HISTORIC AND DESIGN REVIEW COMMISSION

2017-214

309 N ALAMO ST

Demolition of a rear addition

1951 SANBORN MAP

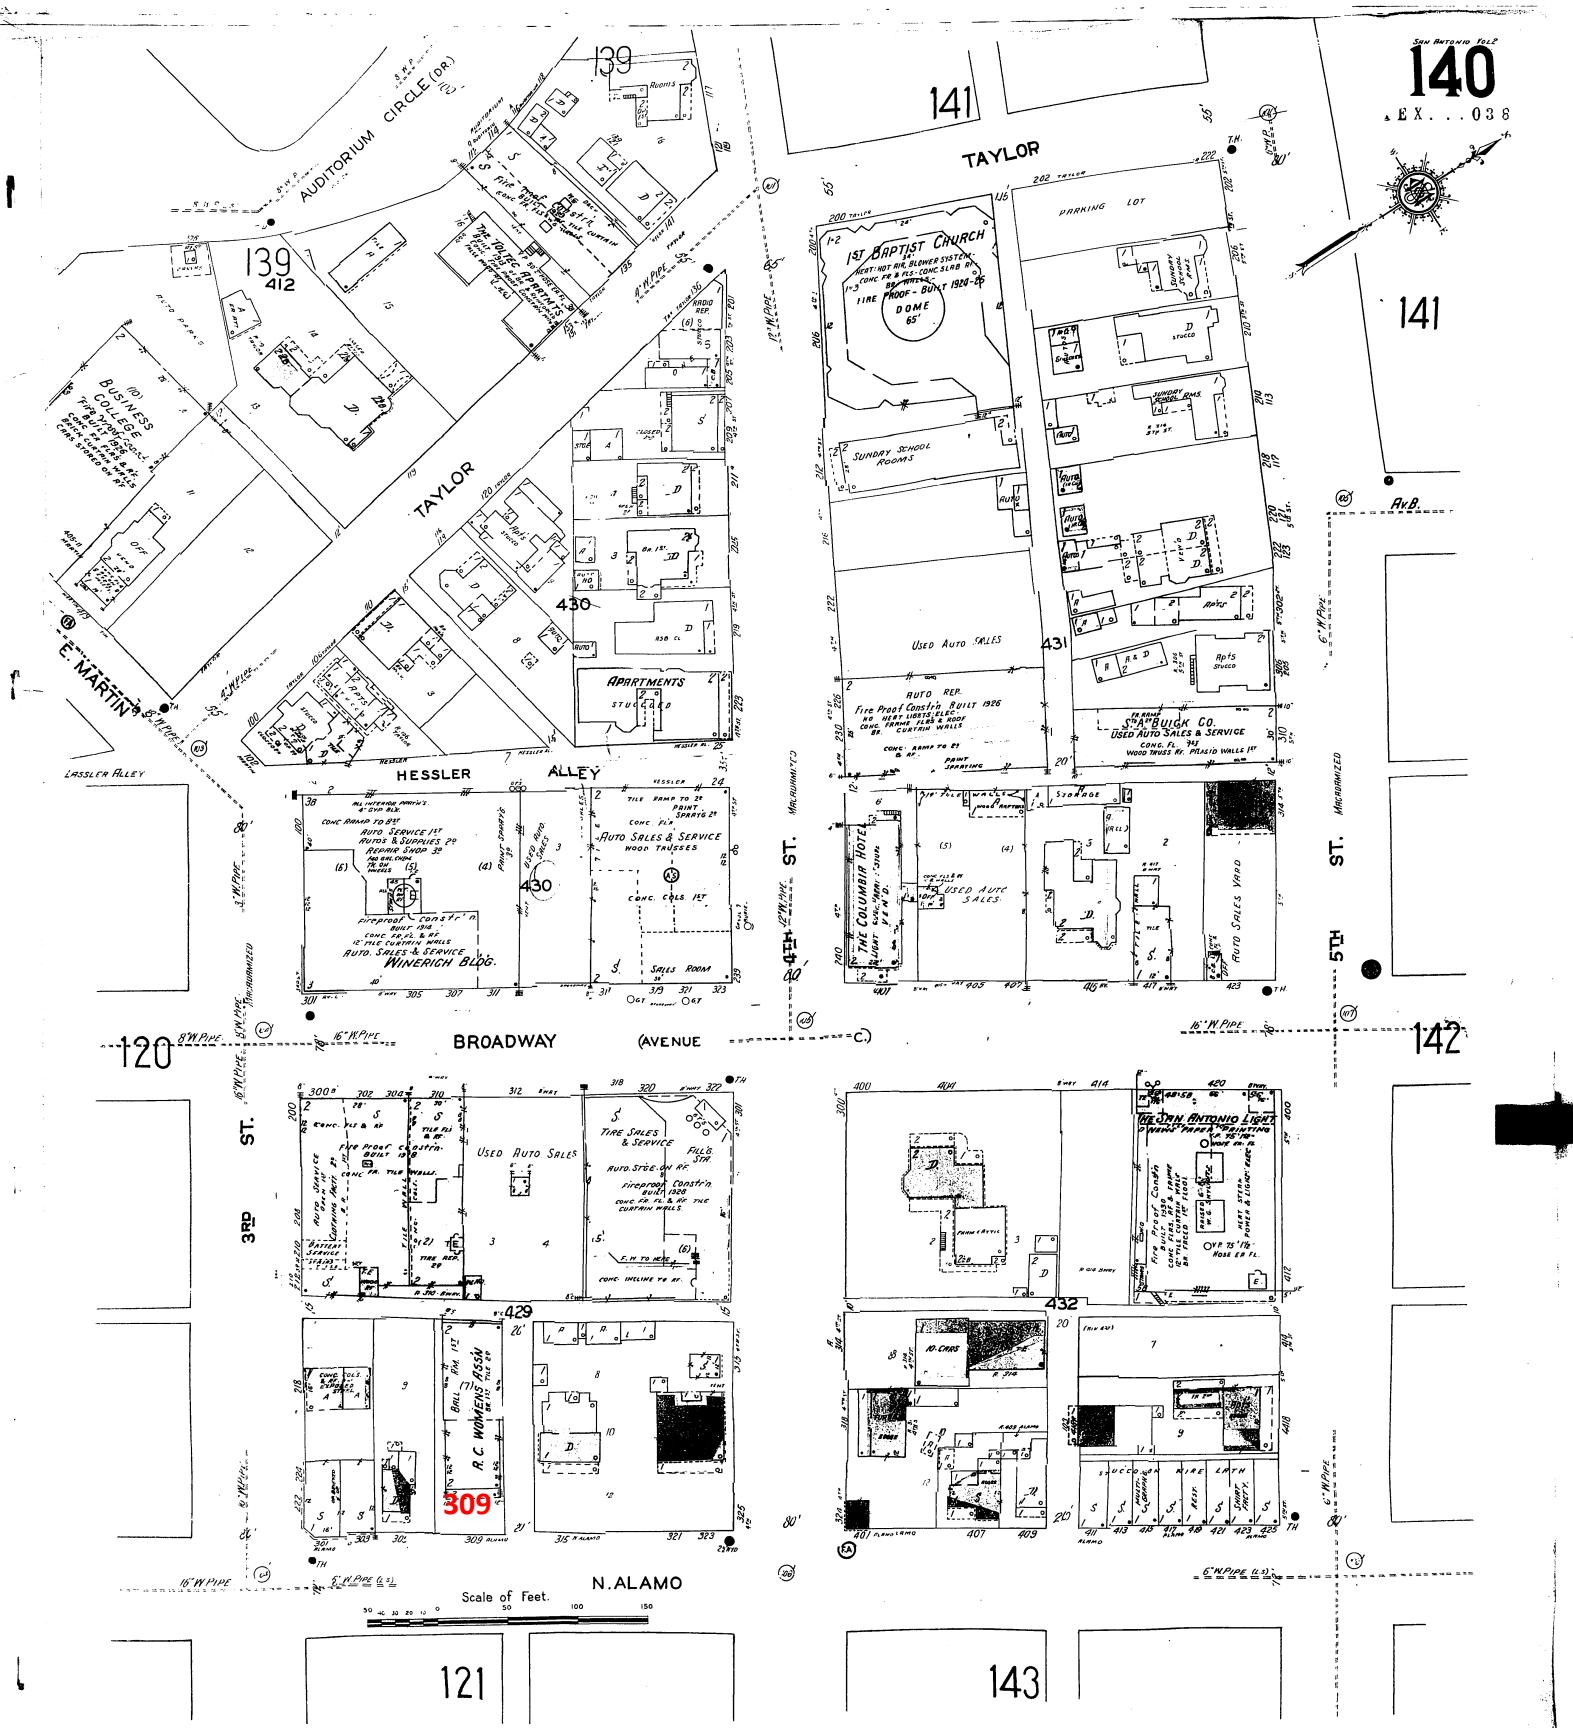
- a. The structure at 309 N Alamo was constructed in 1899 in the Folk Victorian style and features single story columns on both the first and second levels, a plaster covered brick façade, a decorative roof parapet and a long slope shed porch roof. The rear addition features two stories, a brick façade and modern proportioned window and door openings. This addition was construction circa 1945 and first appears on the 1951 Sanborn Map. Within this request, the applicant has proposed to demolish this rear addition.

Portion to be Demolished Rear (1940 Addition)

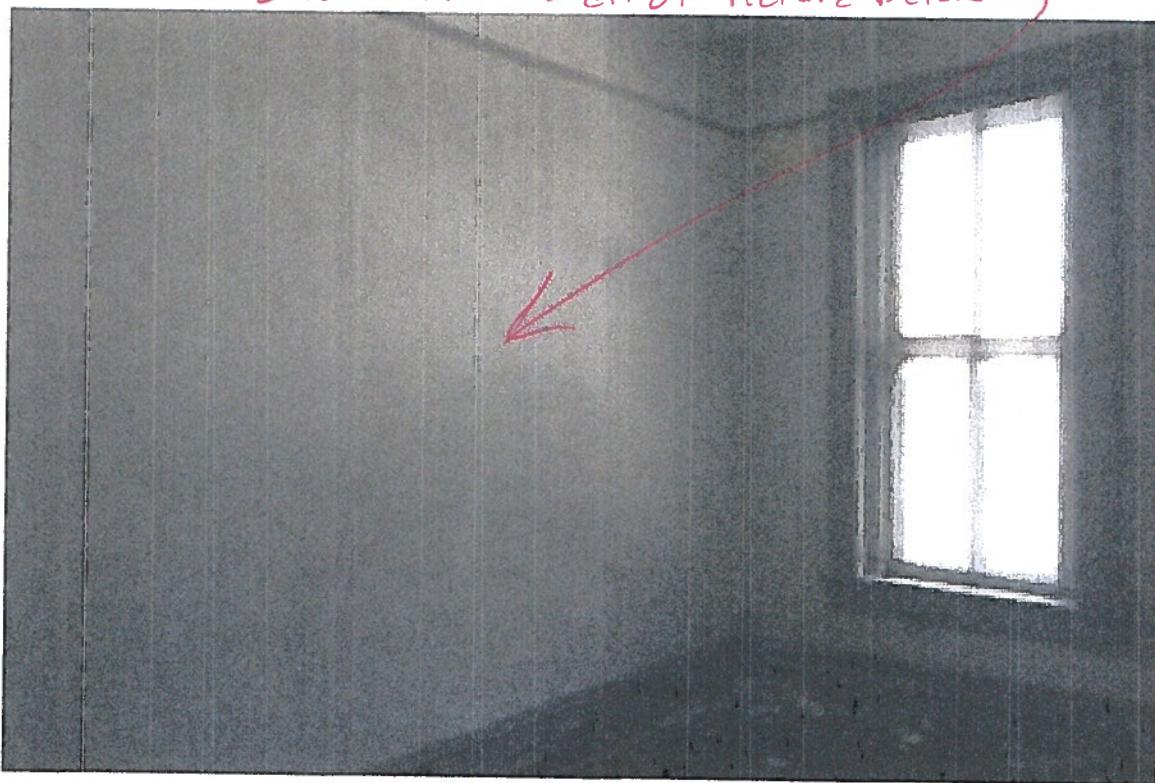
- c. While staff finds the removal of the rear addition appropriate; staff finds that architectural documents including a rear elevation, floor plans and detailed wall sections of the rear wall are to be submitted to staff prior to the issuance of a Certificate of Appropriateness and permits.

Staff recommends conceptual approval based on finding b with the stipulation that architectural documents including a rear elevation, floor plans and detailed wall sections of the rear wall are to be submitted to staff prior to the approved by the HDRC prior to the issuance of a Certificate of Appropriateness.
